**FEDERAL AVIATION ADMINISTRATION  
AIRWORTHINESS DIRECTIVES**

**LARGE AIRCRAFT  
BIWEEKLY 2016-06**

*3/7/2016 - 3/20/2016*

**Figure 1 to paragraph (g) of this AD - Location of date (MM-YY)**

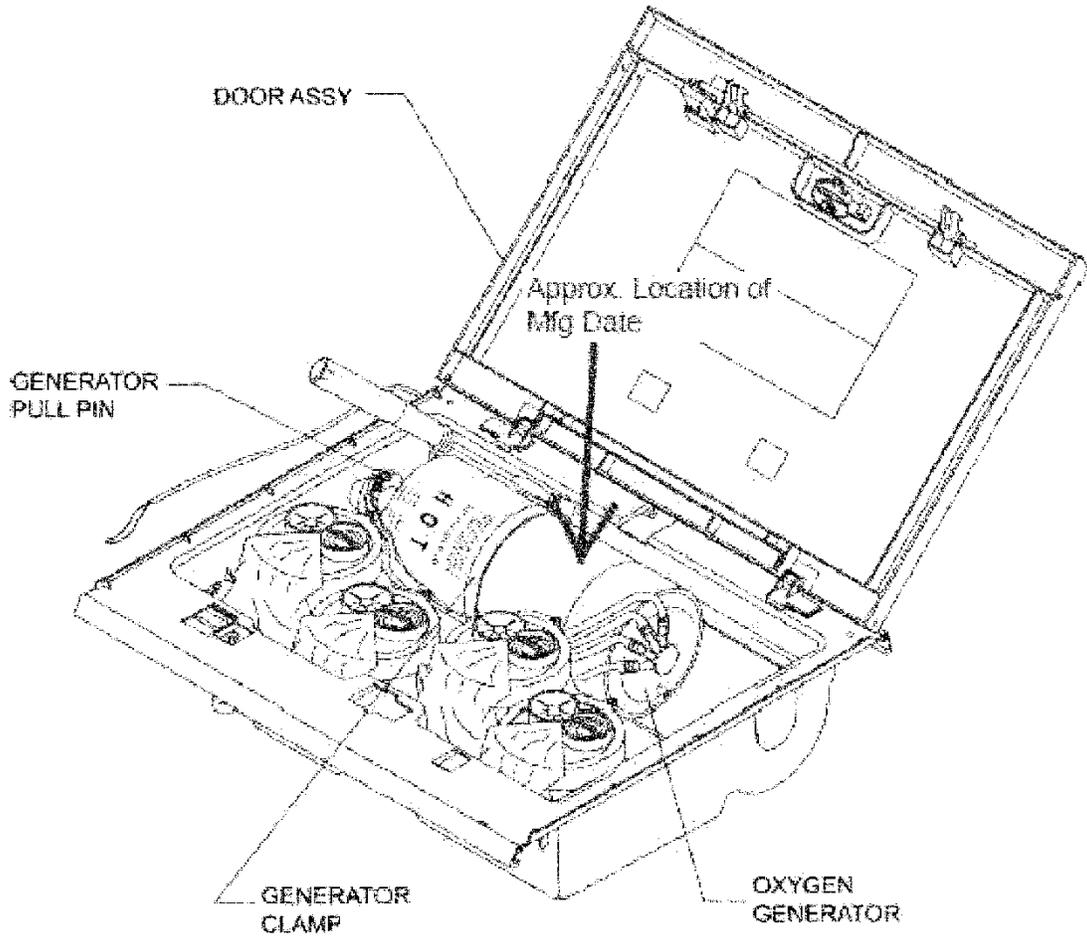
Within 30 days after the effective date of this AD: Inspect each passenger chemical oxygen generator to identify the date of manufacture (refer to figures 1 and 2 to paragraph (g) of this AD for the location of the date) of each passenger chemical oxygen generator having any part number (P/N) listed in paragraphs (g)(1) through (g)(6) of this AD, in accordance with the Instructions of Airbus Alert Operators Transmission (AOT) A35L007-14, Revision 01, June 17, 2015, including Appendix A, Revision 01, dated June 17, 2015. A review of airplane maintenance records is acceptable in lieu of this inspection if the date of manufacture of the generator can be conclusively determined from that review.
